Support Structure Concept Discussion

Justin Stevens
October 22, 2015

TOF upper support beam limits z-position of bars

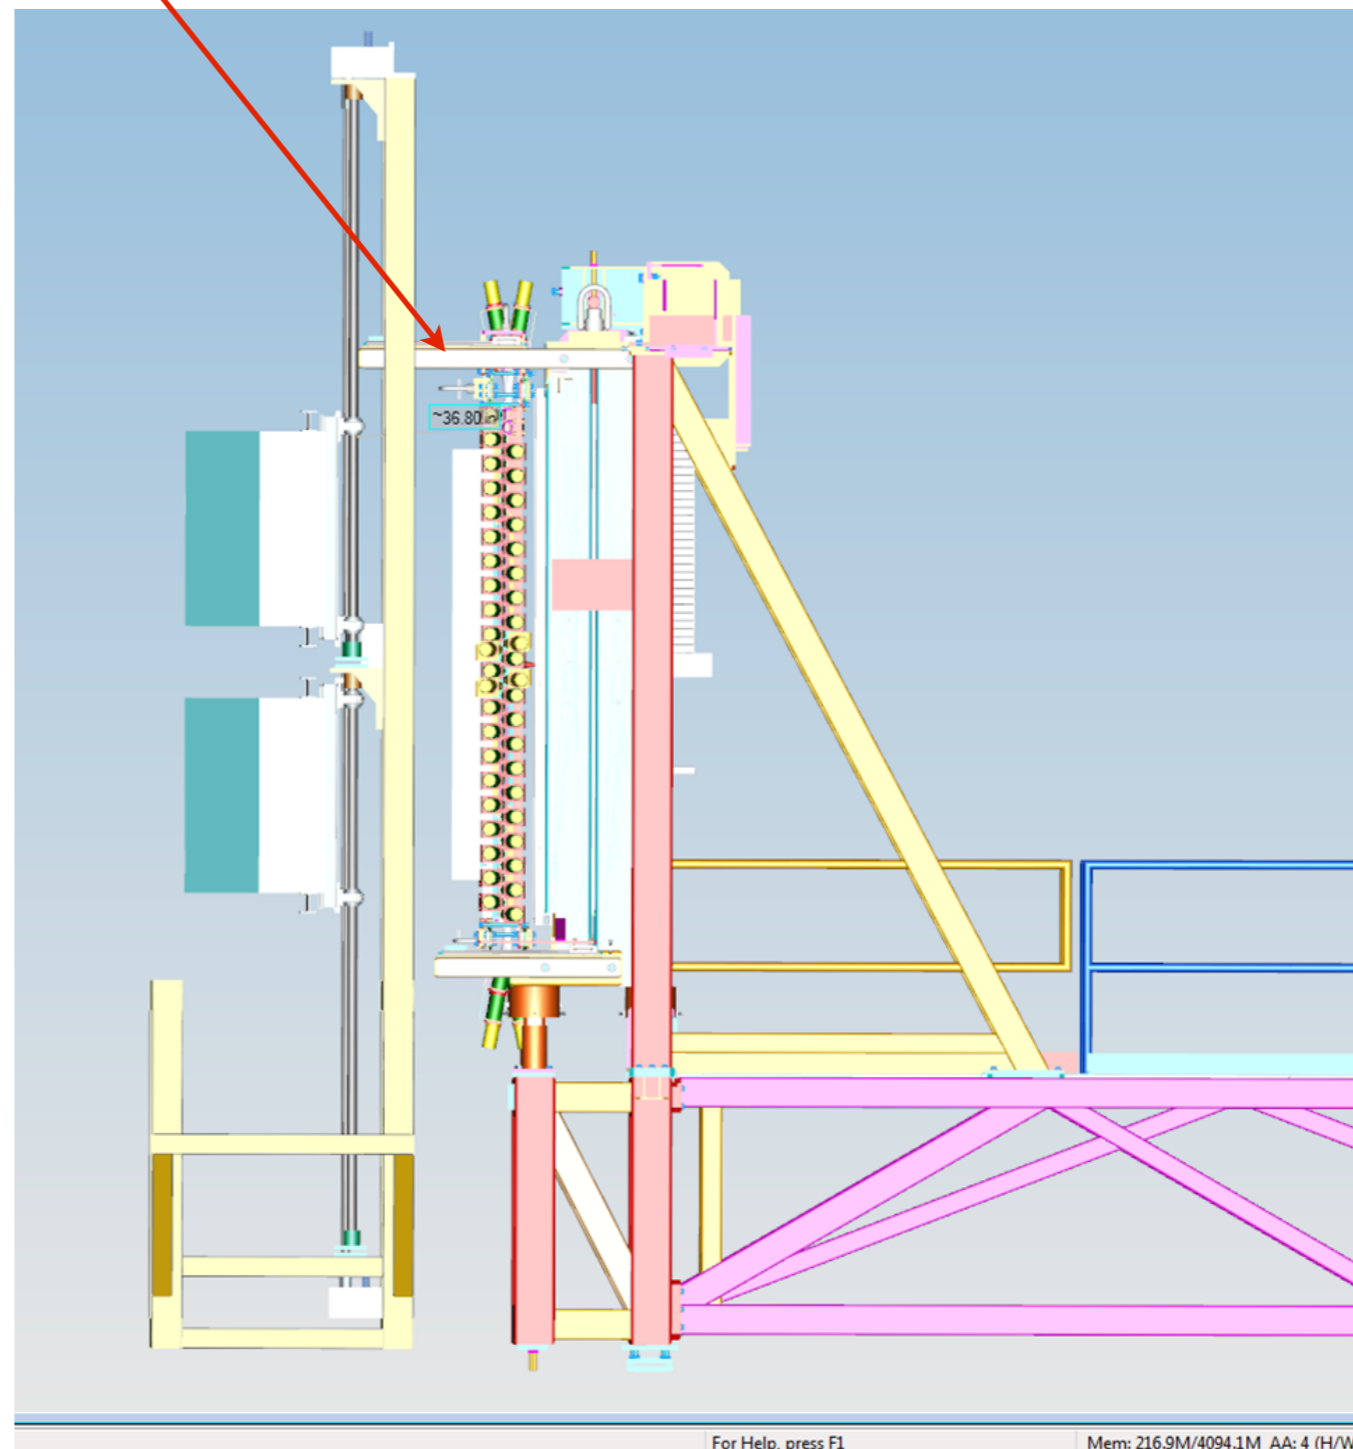
Current support structure concept

* **Pros:**

- * Bar boxes can “easily” be moved out of the forward acceptance
- * The support structure fits in the available space with the current TOF support beams (per Tim)

* **Cons:**

- * DIRC bars are ~30 inches in front of the TOF plane
- * EM showers can start “far” upstream of the FCAL (photon losses?)
- * Polar angle acceptance of the bar boxes is more limited the closer it is to the solenoid (ie. need to move boxes closer to the beamline)

* **Questions:**

- * What is the impact on DIRC performance vs z-position of bars?
- * What is the impact on FCAL performance vs z-position of bars?

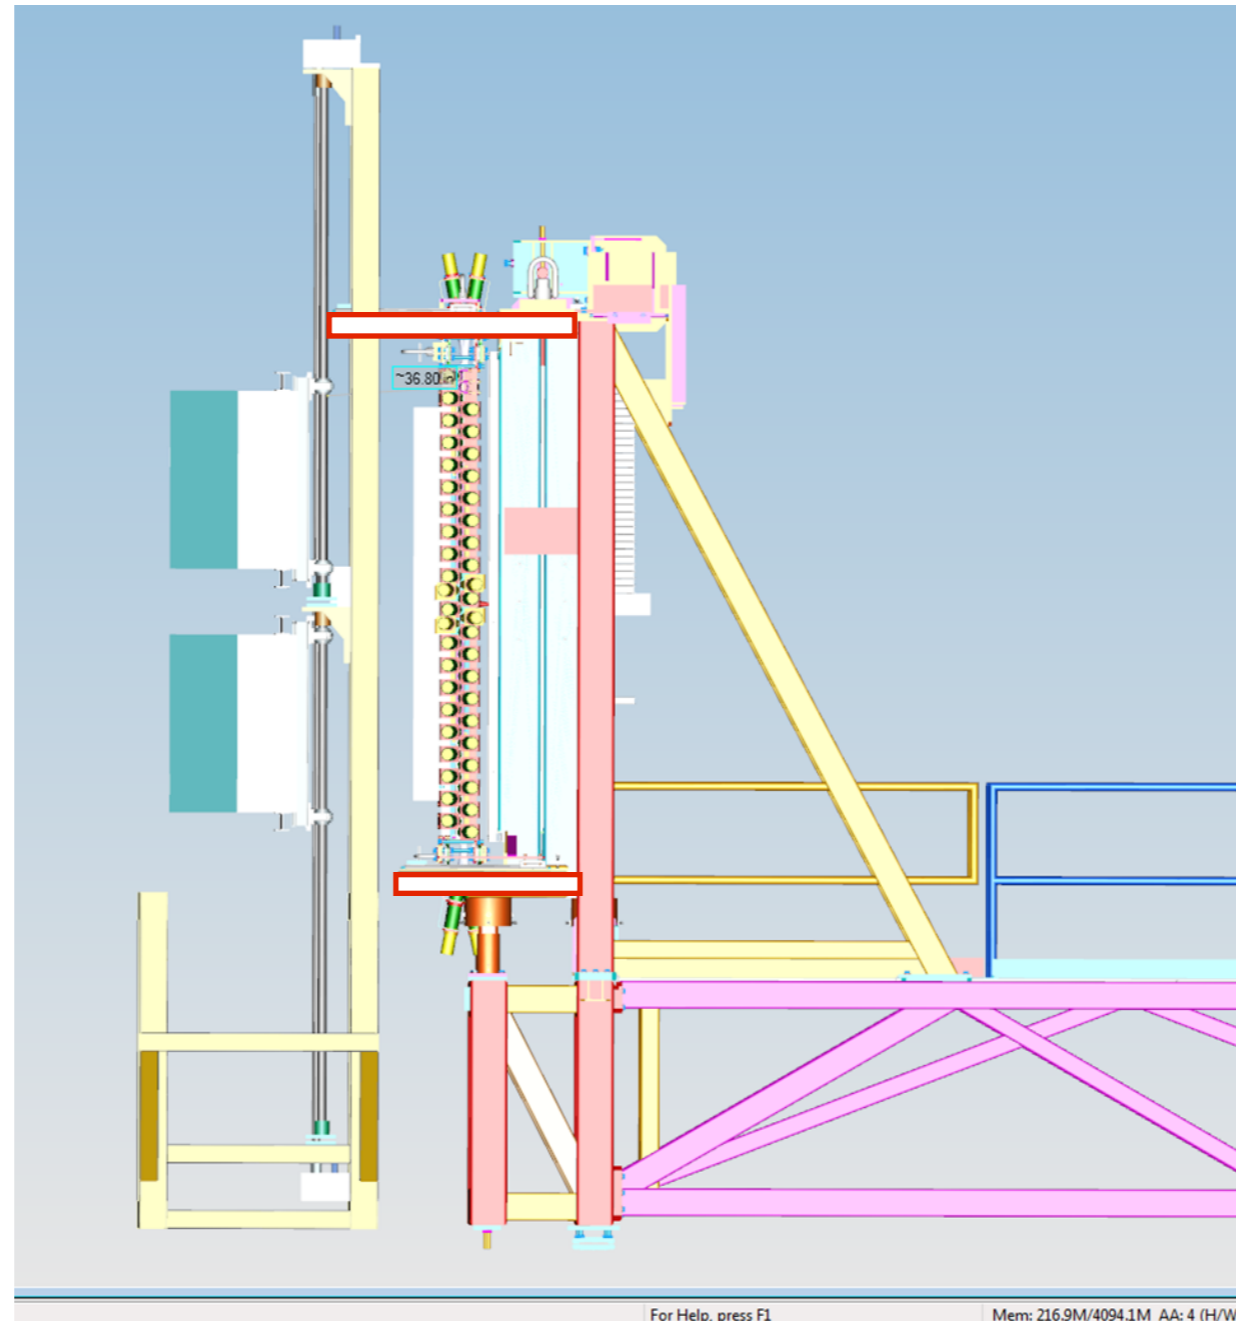
Possible alternatives

- * **Shorten TOF support beams**

- * Must remove TOF entirely, modify supports and re-install (significant effort)
- * May lose some capability to UV cure FCAL Pb-Glass blocks

- * **Provide ability to keep DIRC in fixed location while rolling the forward carriage**

- * After forward carriage is rolled back one can move DIRC bars up/down or provide space to slide TOF on support beams for UV curing of FCAL
- * Requires alternative (temporary) method of supporting DIRC without forward carriage

Current support structure

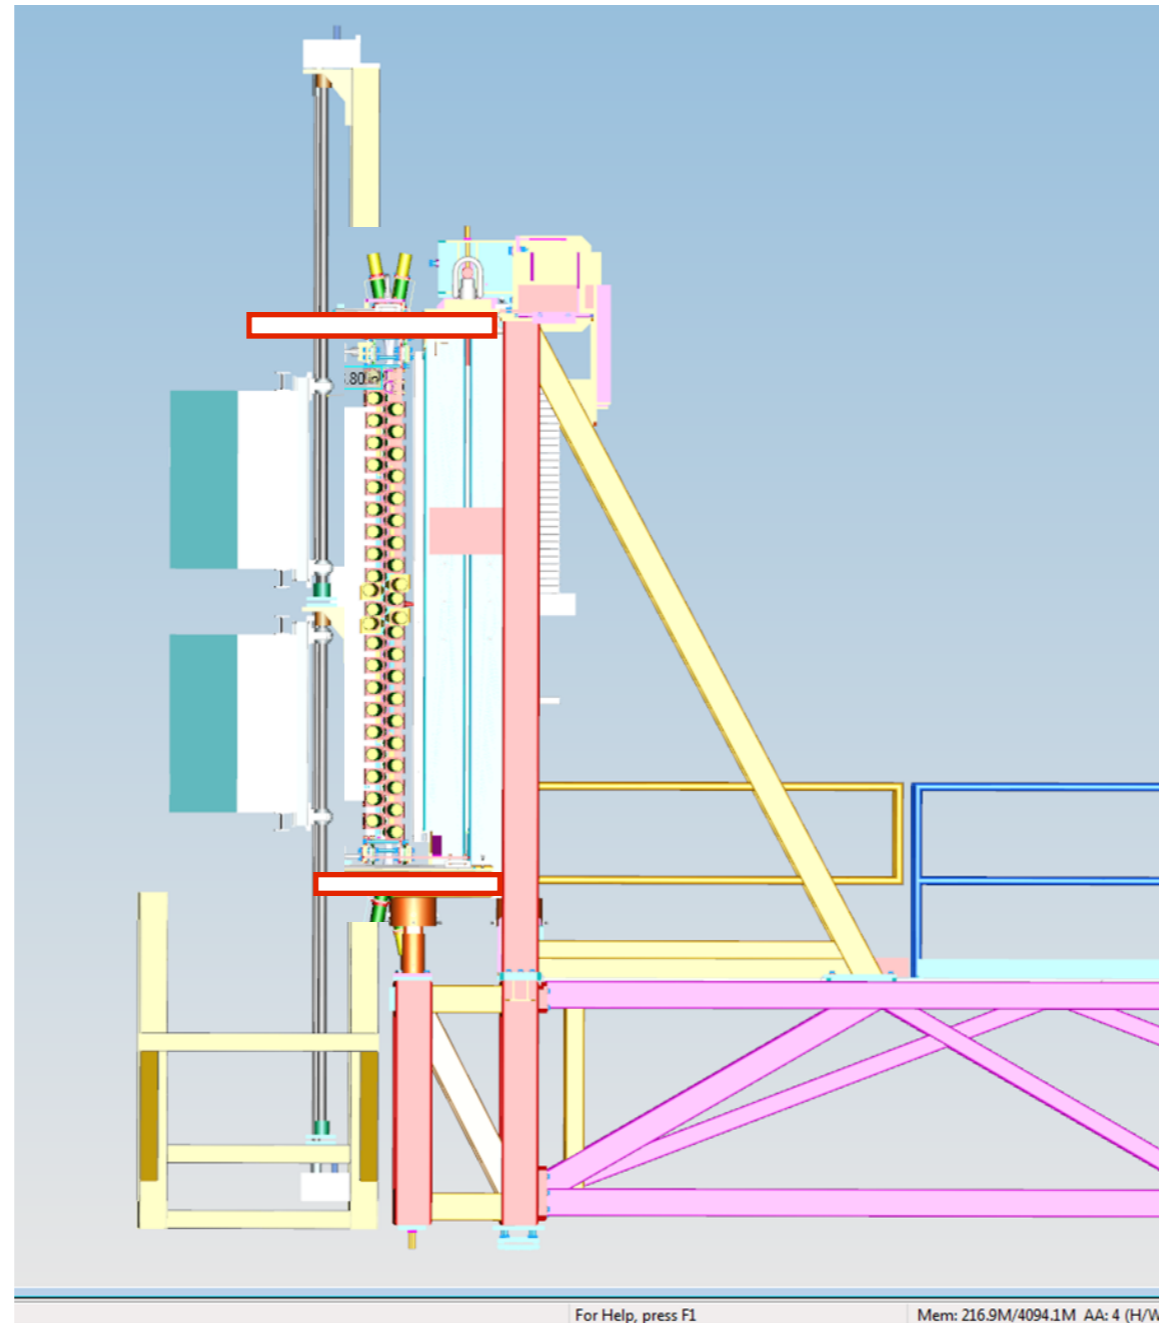
Prefer closer to TOF plane

Can't move DIRC bars out of active area

Roll FCAL carriage without DIRC

View from upstream

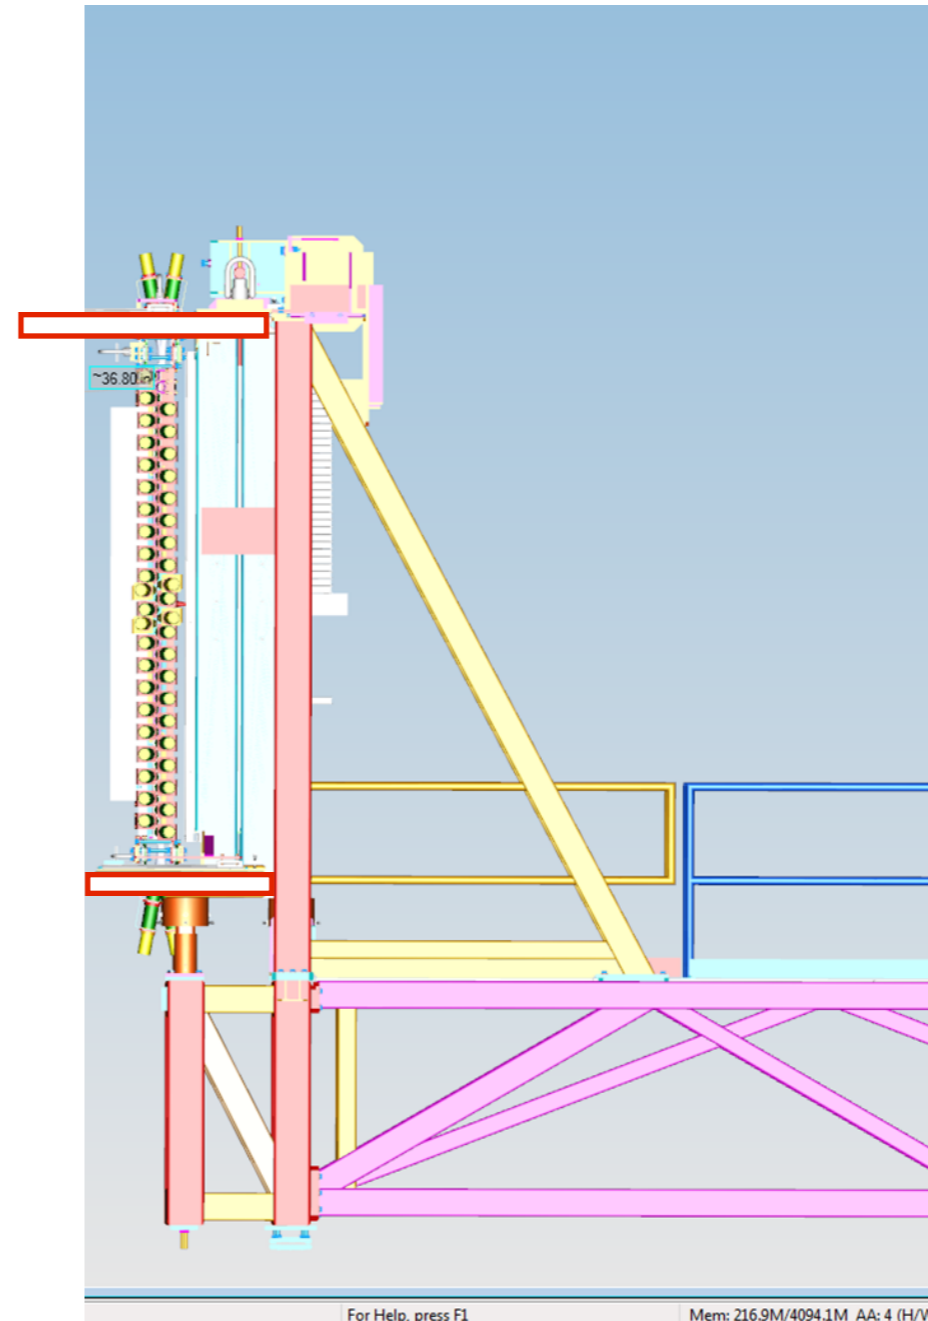
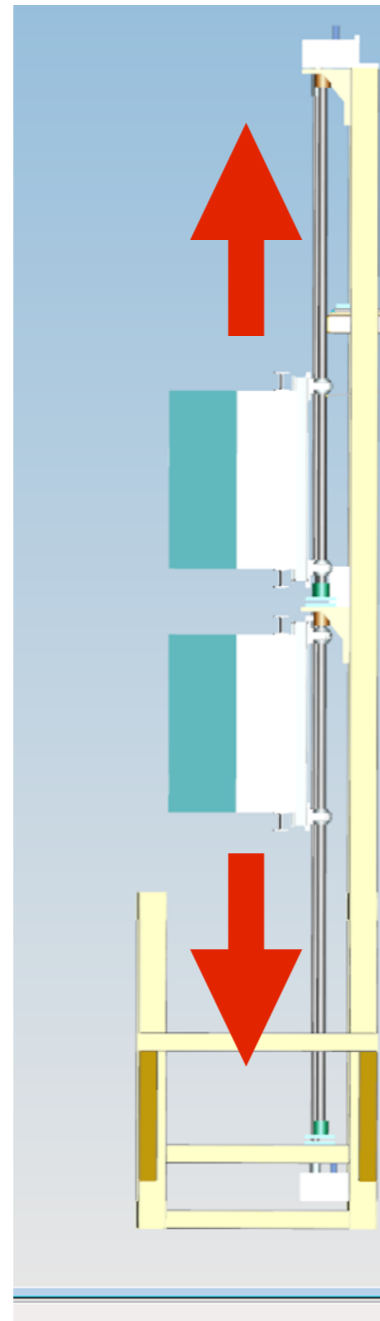
Requires separate support (on solenoid carriage?)
